# Access Compliance Report

## Public Rights-of-Way

Intersection ID: 21312	Main Street: E_ARROWOOD_RD	Cross Street: SOUTH_BV	Location: SW
ADA ID: 89B432434AC8	Ramp Type: Perp	Initial Pass/Fail: Fail	Overall Compliance: No
		Severity Score: 12.5

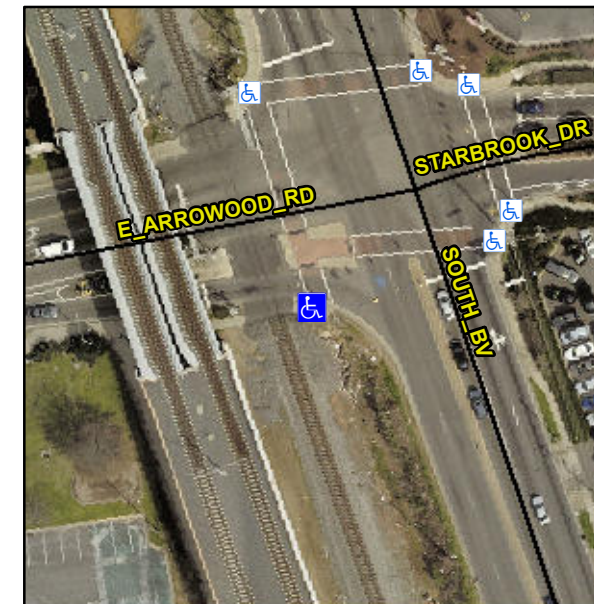
Compliance	Description	Data	Compliance	Description	Data
N/A	Ramp Length (in)	71.0	No	Ramp Slope (%)	8.7
Yes	Ramp Width (in)	48.0	Yes	Ramp XSlope (%)	1.5
N/A	Flare Type LT	N/A	N/A	Flare Type RT	N/A
N/A	Flare Slope LT (%)	N/A	N/A	Flare Slope RT (%)	N/A
N/A	Flare Traversable LT?	N/A	N/A	Flare Traversable RT?	N/A
N/A	Landing Length (in)	N/A	N/A	DWS Provided?	N/A
N/A	Landing Width (in)	N/A	N/A	DWS Contrast?	N/A
N/A	Landing Slope (%)	N/A	N/A	DWS Length (in)	N/A
N/A	Landing X Slope (%)	N/A	N/A	DWS Full Width?	N/A
N/A	Landing Curb? (Y/N)	N/A	N/A	DWS Offset (in)	N/A
N/A	Shared Landing?	N/A			
N/A	Gutter Ponding?	N/A	N/A	Gutter Slope (%)	N/A
N/A	Gutter Lip Ht (in)	N/A	N/A	Gutter X Slope (%)	N/A
N/A	Painted X Walk1?	Yes	N/A	Painted X Walk2?	N/A
	X Walk 1 Direction	To N		X Walk 2 Direction	N/A
N/A	X Walk 1 Width (in)	126.0	N/A	X Walk 2 Width (in)	N/A
	X Walk 1 Slope (%)	2.5		X Walk 2 Slope (%)	N/A
	X Walk 1 X Slope (%)	3.6		X Walk 2 X Slope (%)	N/A

**Remove & Replace Entire Ramp.**

**R304.2.2**
